# Corporate Report

**SUBJECT:** **Report on Comments – Draft Port Credit Local Area Plan And  
Built Form Guide - Ward 1**

**Response To Comments Table – Draft Port Credit Local Area Plan**

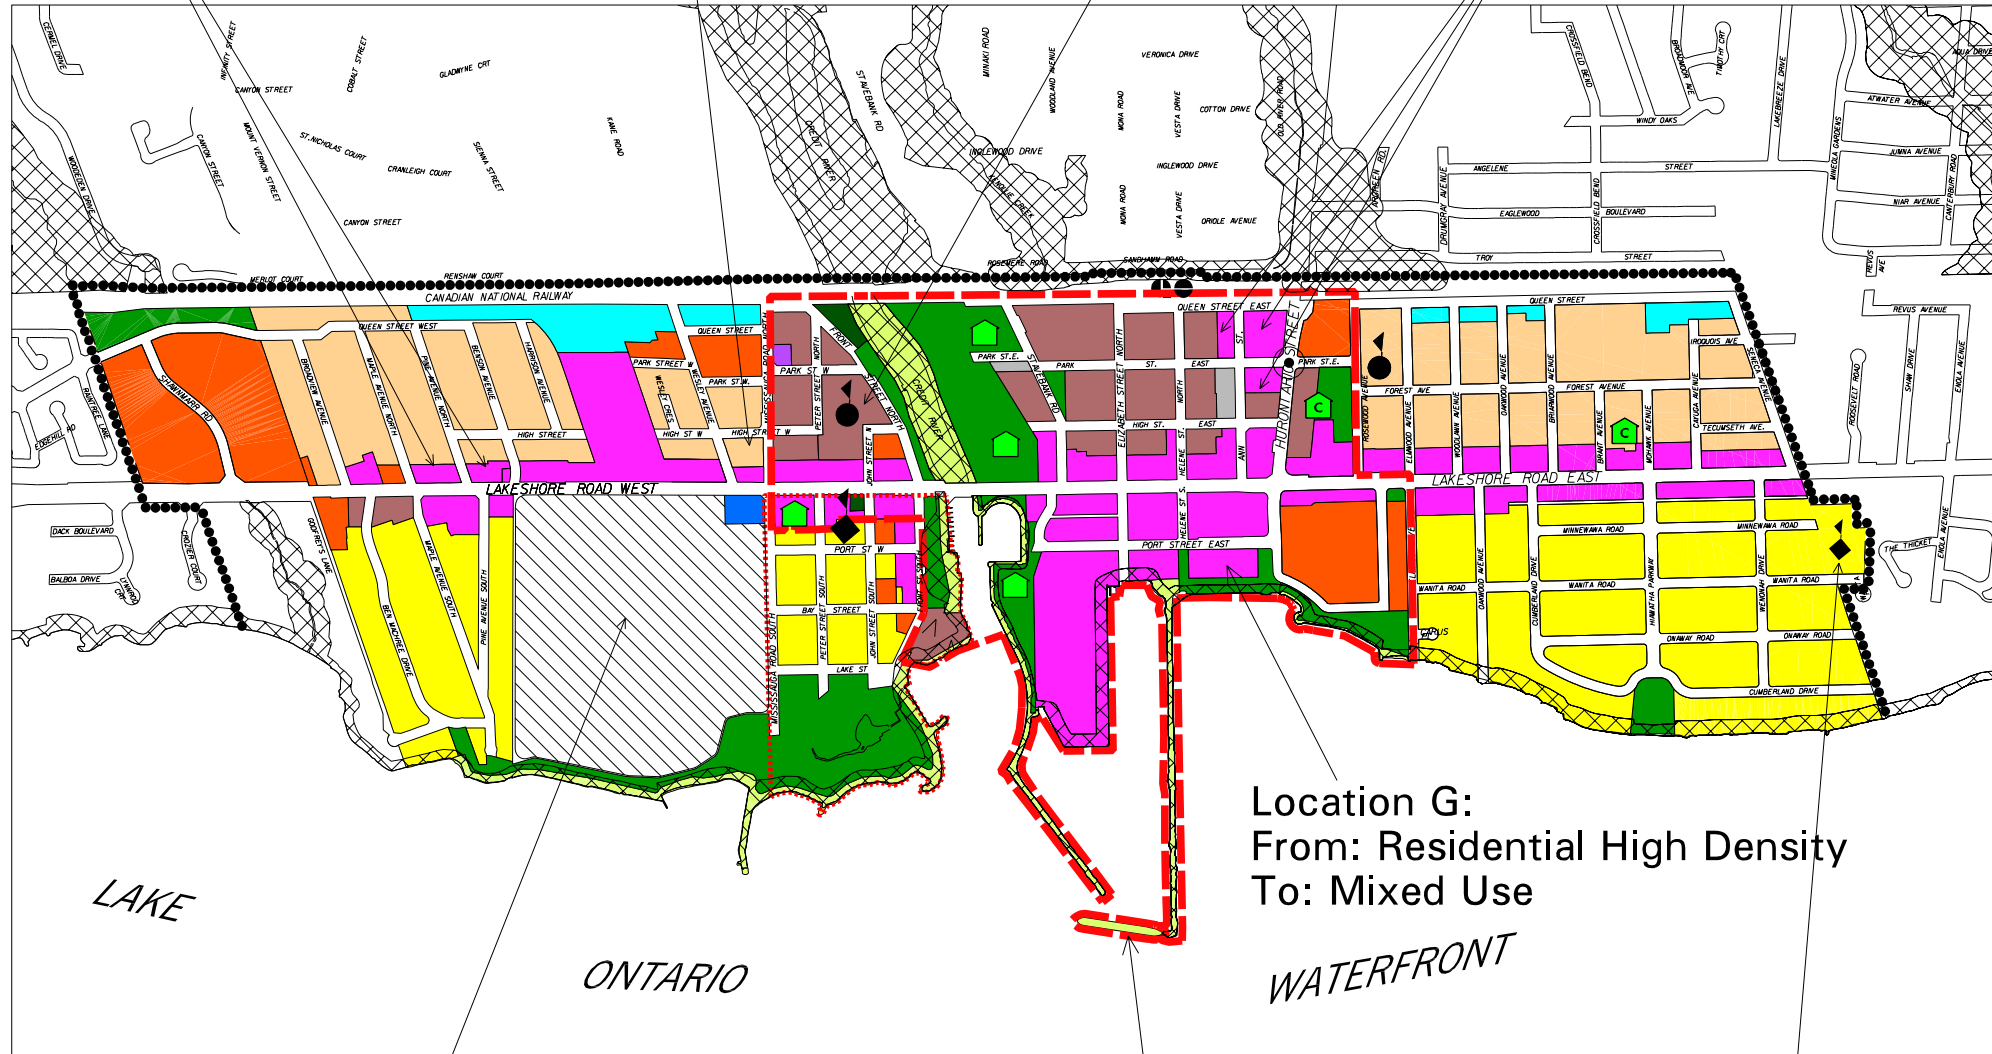
Location D:  
From: Residential Medium Density  
To: Residential High Density

Location C:  
From: Residential High Density  
To: Residential Low Density II

Location E:  
From: Residential High Density  
To: Mixed Use

Location F:  
From: Lake Ontario  
To: Greenbelt (with Ridgetown breakwater being added)

# Potential Opportunities for Road Network Improvements and Higher Order Transit

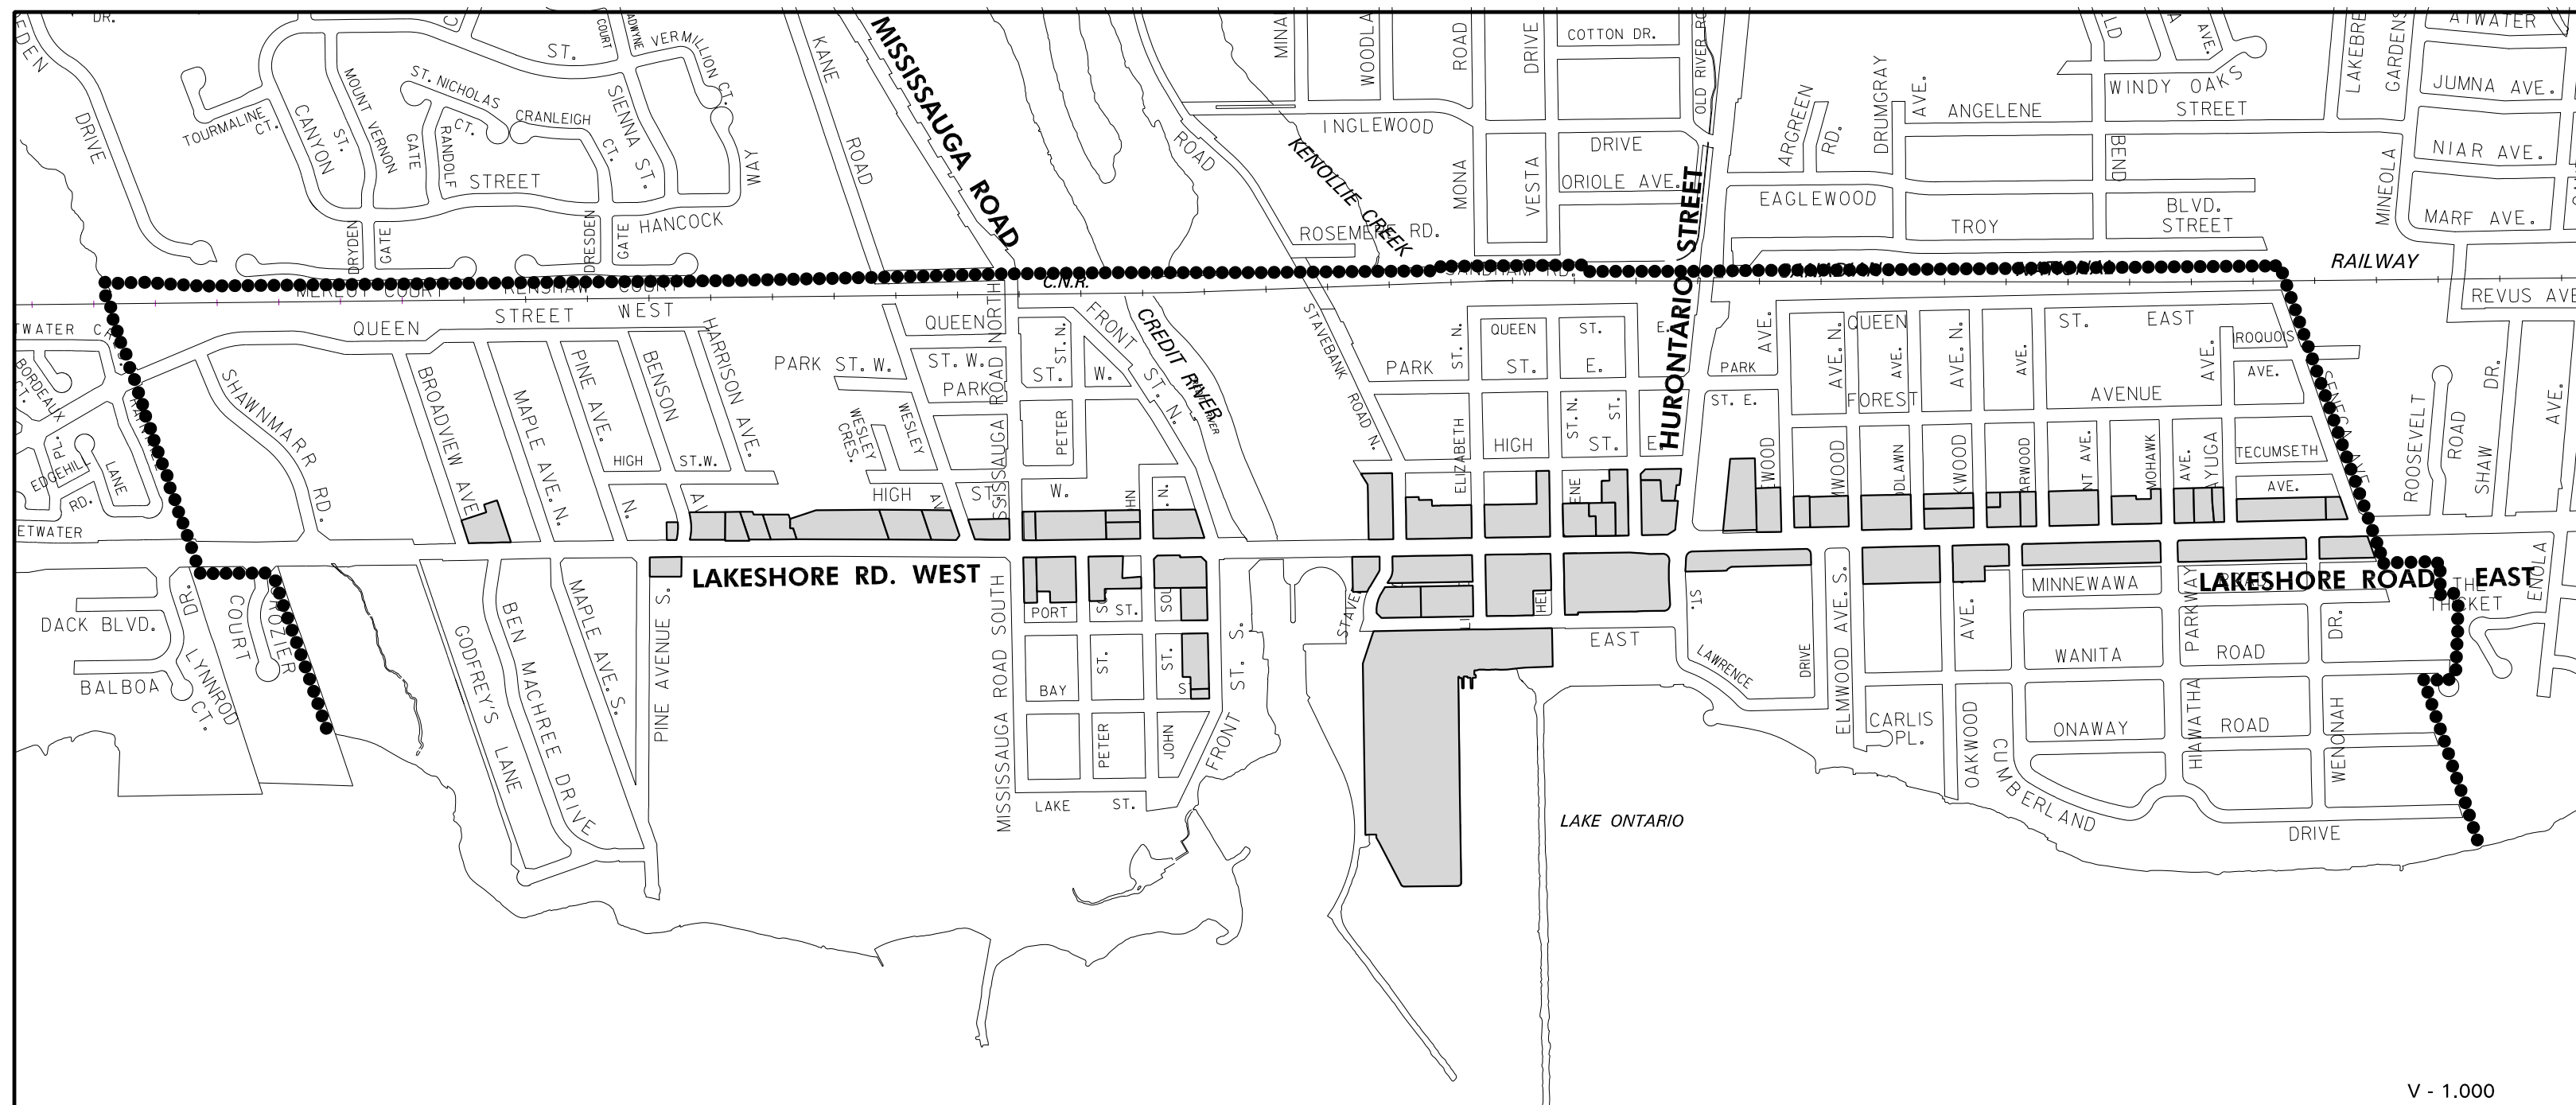
- identifying opportunities for road connections that promote a fine grain road network. Potential road connections would be evaluated should an application to redevelop a property be submitted or through a Transportation Master Plan. A figure will be added to the Area Plan to illustrate these opportunities (see Appendix 6);

Transportation	9.1.13 Multi-Modal	Local Area Plan	Agreed.	26 That a new figure be added that

Respondent	Section	Issue	Comments	Recommendation To Draft Port Credit Local Area Plan
and Works	Network	should conceptually illustrate potential road and transit network improvements.		illustrates potential opportunities for road network improvements and higher order transit.
Transportation and Works	9.1.14 Multi-Modal Network	Local Area Plan should clarify that transportation and traffic studies are required for new development in Port Credit and that these studies have to identify strategies for limiting impacts.	Agreed.	27 That a new policy 9.1.14 be added to read:  <i><u>Development applications will be accompanied by transportation and traffic studies. Studies will address, amongst other matters, strategies for limiting impacts on the transportation network, where appropriate, including measures such as:</u></i>  <ul style="list-style-type: none"> <li>- <i><u>reduced parking standards;</u></i></li> <li>- <i><u>transportation demand management;</u></i></li> <li>- <i><u>transit-oriented design of the development;</u></i></li> <li>- <i><u>pedestrian/cycling connections; and</u></i></li> <li>- <i><u>access management plan.</u></i></li> </ul>
